1008 Lake Street

DESIGN RECOMMENDATION CONFERENCE 2
CITY OF KIRKLAND
DRV 15-01250

DRC 1 SUMMARY
08.24.15

DRC 2: DESIGN RESPONSE

DRC1: Modulation Study

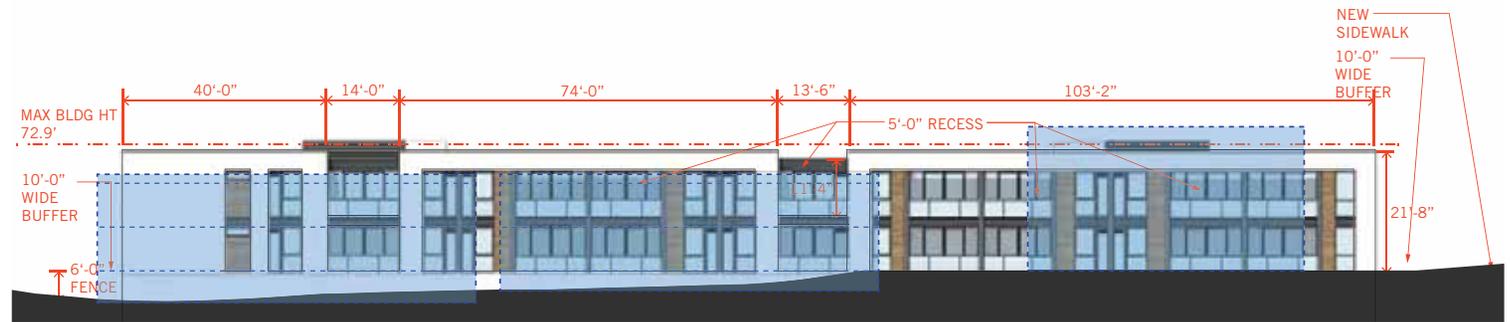
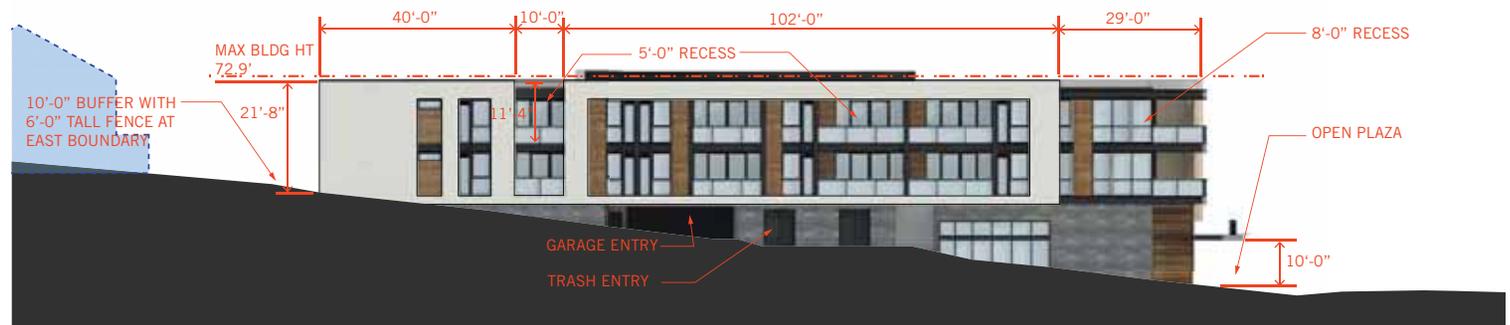
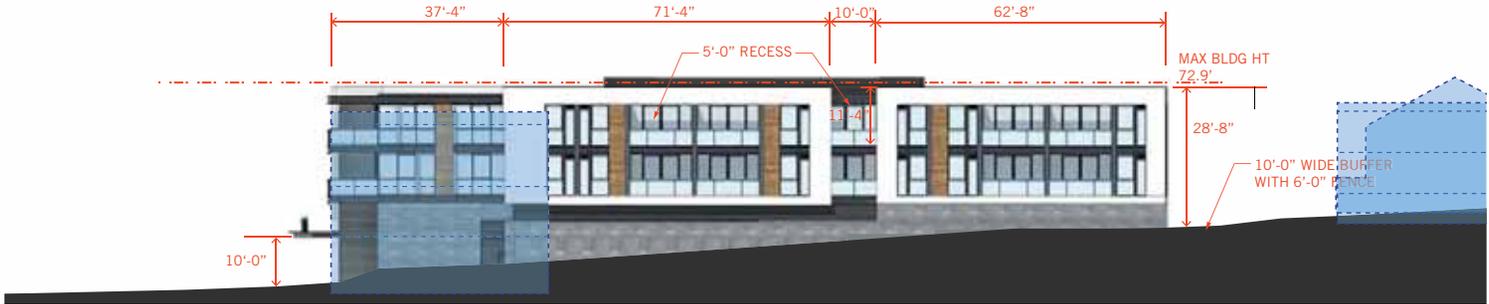
RESPONSE 1	
A1	Study Modulation of all elevations of building.
A2	Reduce the feeling of bulk with meaningful modulation.
A3	Reduce 19' commercial floor to reflect pedestrian scale of area.
A4	Explore rooftop modulation.

RESPONSE 1	
A1	Building facade maximum length is reduced from 125'-0" per zoning code allowance. The average facade length is 60'-0", with one exception at 102'-0".
A2	Building bulk is reduced by application of 'punches' to recess the building facade 5' to 8' back on all facades to increase visual interest and reduce the 'solid feel' of massive walls.
A3	Commercial floor to ceiling height is reduced to 16'-0", in addition a continuous canopy will be installed at 10'-0" above sidewalk to create an amicable pedestrian atmosphere.
A4	Rooftop modulation is applied with facade modulation at intervals where the parapet is stepped down.

COURTYARD

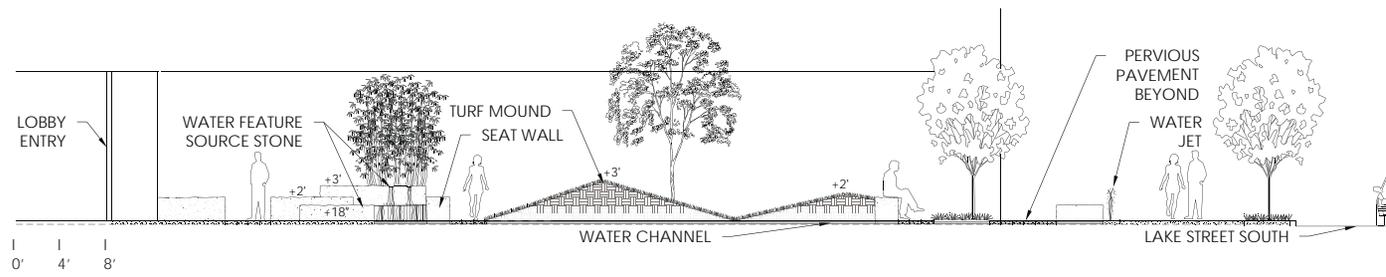
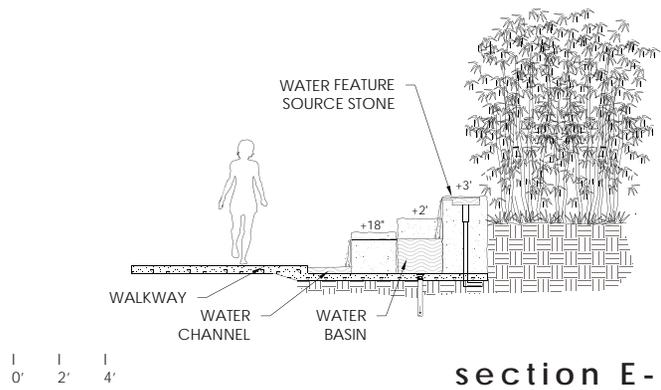
RESPONSE 2
18 Refer to landscape design drawings.

NEW EAST ELEVATION

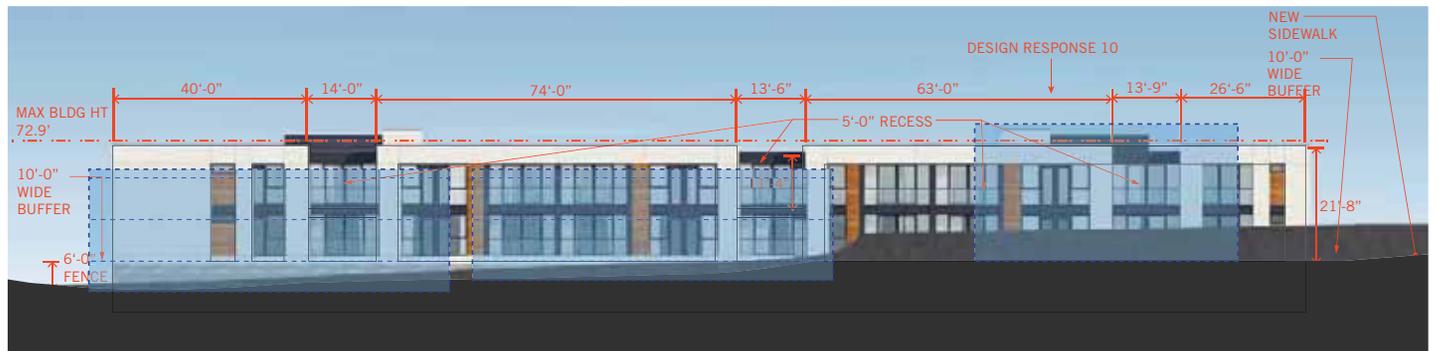
RESPONSE 2	
7	We have lowered the floor to floor height in residential portion 6" each to allow for 12" more difference between the frames and general roof. Together with more modulation and revised front facades, there is more variation in the roof profile.
8	The white "picture frames" are revised to an open shape that fits with the design language and scale. We have revised the color of the frames and changed window pattern within the frames in the courtyard.
9	The back courtyard elevation remains predominantly dark with wood texture elements in contrast to lighter colored wings to represent a connector like element between two buildings rather than one continuous facade.
15	Design proposed a step-down (2ft) at the corner and has been changed to an Open Shape rather than the Picture Frame.
10	Design revised East Facade reducing the previous large block from 103'-6" to two smaller blocks as shown.

11	Shifting the East courtyard wall would decrease the size of the courtyard and would conflict with the amount of required pervious surface outlined by the EIS report and conflict with the allowable amount of lot coverage.

Design Response: Wall Sections

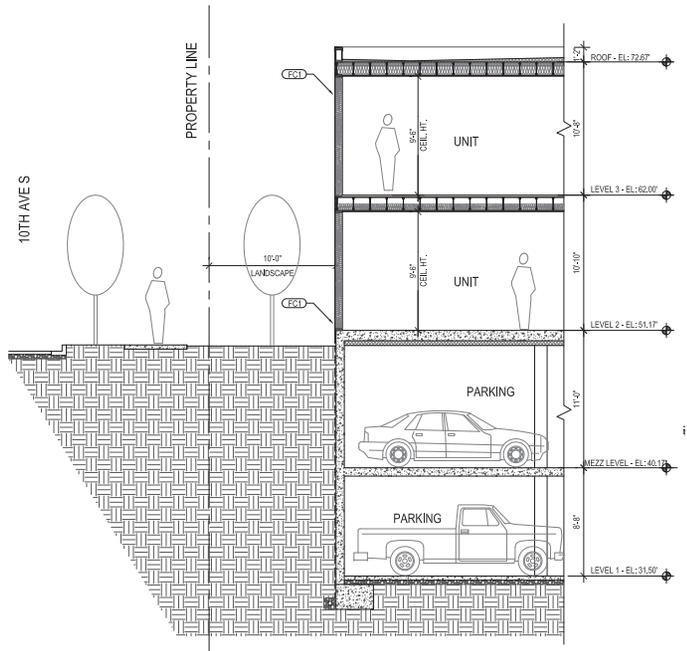
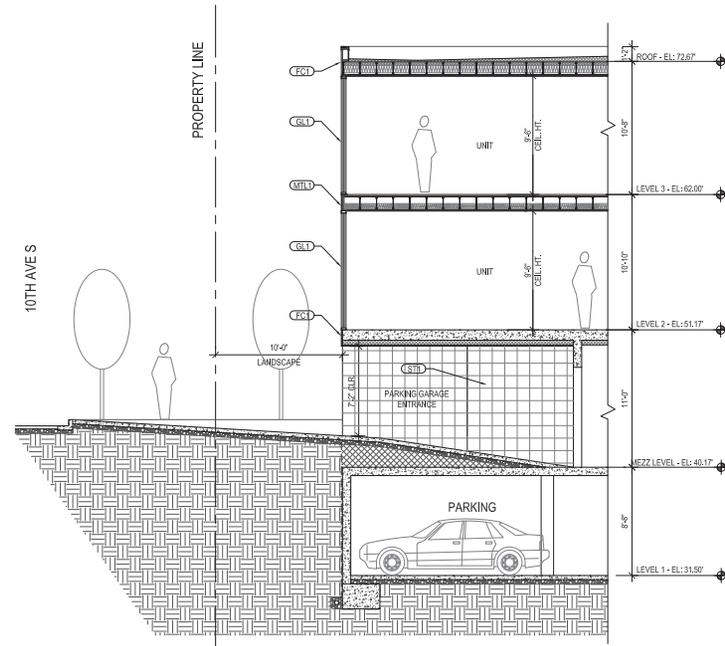
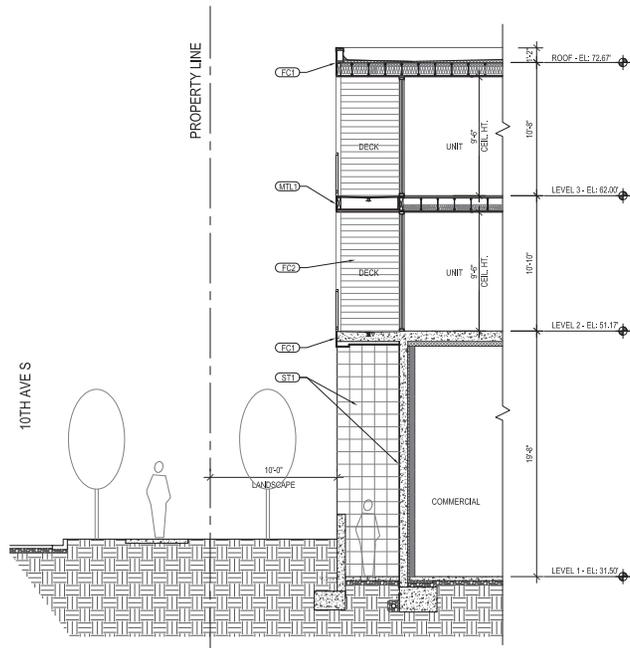
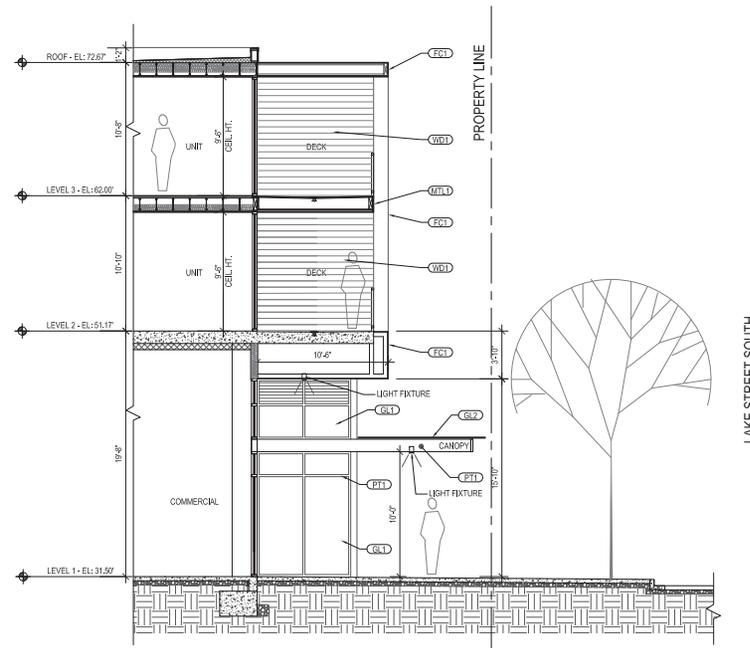
12	Provide wall sections through building as it climbs 10th Ave. S	Wall Sections on 10th Ave South.	Page 34
13	Show how cantilever will work (wall sections)	Wall Sections at the cantilever on Lake Street	Page 34
14	Review if proposed amount of glazing is allowed (energy modeling)	We have both reduced the amount of residential glazing as well as conducted a preliminary component energy calculation. We are planning to increase the roof, wall and slab insulation factor, and together with the use of high efficiency windows, this project will meet the requirements of energy code.	Page 31
15	Study step back of upper floors at corners	Design proposed a step-down (2ft) at the corner and has been changed to an Open Shape rather than the Picture Frame.	Page 30
16	Study possibility of moving driveway closer to Lake St. S to reduce height of ground floor commercial (can be moved to within 50 ft. of Lake St. S per Public Works review)	Relocation of drive-way entrance is not feasible with public-works requirements and would create a traffic and safety hazard with inadequate stacking and visibility to see incoming traffic. In addition it would create difficult internal maneuvering within the parking garage.	Page 24

RESPONSE 2	
12	Wall Sections on 10th Ave South.
13	Wall Sections at the cantilever on Lake Street
